UNITED STATES ENVIRONMENTAL PROTECTION AGENCY  
REGION 5  
77 WEST JACKSON BOULEVARD  
CHICAGO, IL 60604-3590

RE: Area 1: Draft Feasibility Study Report

**U.S.EPA COMMENTS  
ON THE  
AREA 1 FEASIBILITY STUDY  
ALLIED PAPER, INC./PORTAGE CREEK/KALAMAZOO RIVER SITE**

Figure 1 - Temporal decline in wet-weight PCB and lipid content in carp fillets from Kalamazoo, Mosel, and D-Avenue sampling stations.

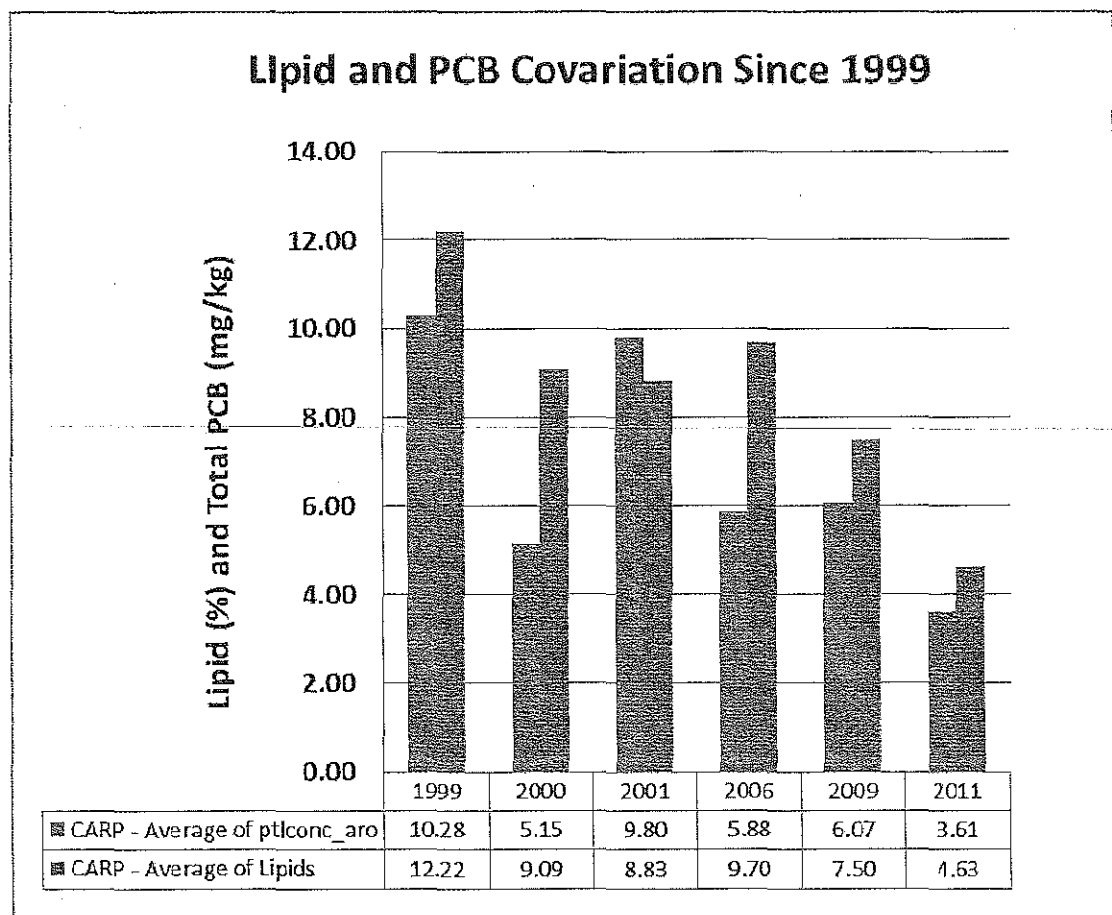
Data evaluations indicate that the trends based on wet-weight PCBs overstate the rate of decline in carp and smallmouth bass tissue samples. Lipid content was found to explain a significant portion of the PCB decline. Therefore, much of the apparent decay of PCBs in tissue is explained by temporal variation in lipid content (see Figure 1 for carp, below). Extrapolation of wet-weight PCB decay trends requires the assumption that lipid content trends will continue to decline through time as well. However, it is not possible for lipids to decline below species-specific minimums; therefore, PCB trend calculations need to consider and compensate for lipid trends. A reasonable approach for future projections is to simply assume that, over time, lipid content will fluctuate between temporary high or low levels, but generally center on a long-term average lipid value. This may be best estimated from the long-run average lipid content within the monitoring data. For this analysis, all fish tissue data were standardized to a common lipid value given by the average lipid content observed in the data for each species from 1993 through 2011. The approach provides a long-term exposure trajectories that reflect PCB concentrations associated with the long-term average lipid level. The lipid-adjusted values are calculated by regressing log (PCB) on log (lipids), calculating the expected PCB concentration for the selected lipid content, and then adding the regression residuals to the expected PCB values. The values represent a sample of fish tissue values, all of which contain the same lipid content. The approach is the mathematical equivalent to selecting fish for analysis with similar lipid levels, and should be used for development of temporal trends in PCB fish tissue concentration.
